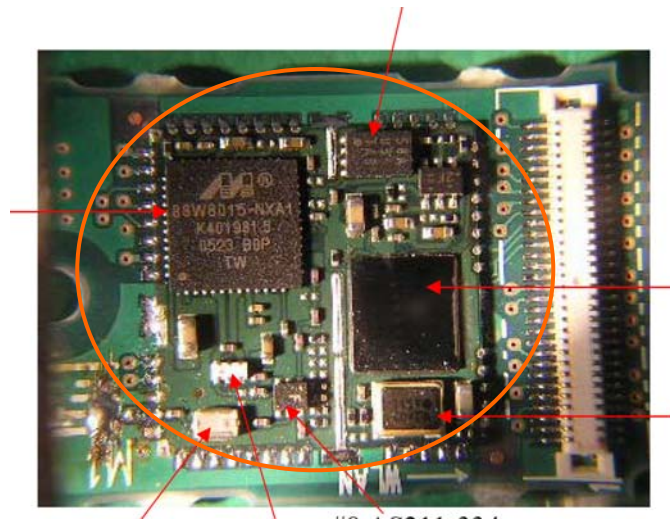
- 2) Generally for internal photographs the FCC desires front and back of each board. It does not appear that the following has been provided a) back of main processing board, b) back of BT antenna, c) Back of BT module, d) back of WLAN daughter board (see below) e) WLAN Antenna and e) top and bottom of any other boards in the device.

OUR ANSWER==> We uploaded "Revised FCC Internal Photo.pdf" and "Revised IC Internal Photo.pdf". Please confirm. We cannot prepare back of WLAN daughter board because it is mounted on the device and nothing on it. From our experience, we think these photos are sufficient for FCC application of Handy Terminal.
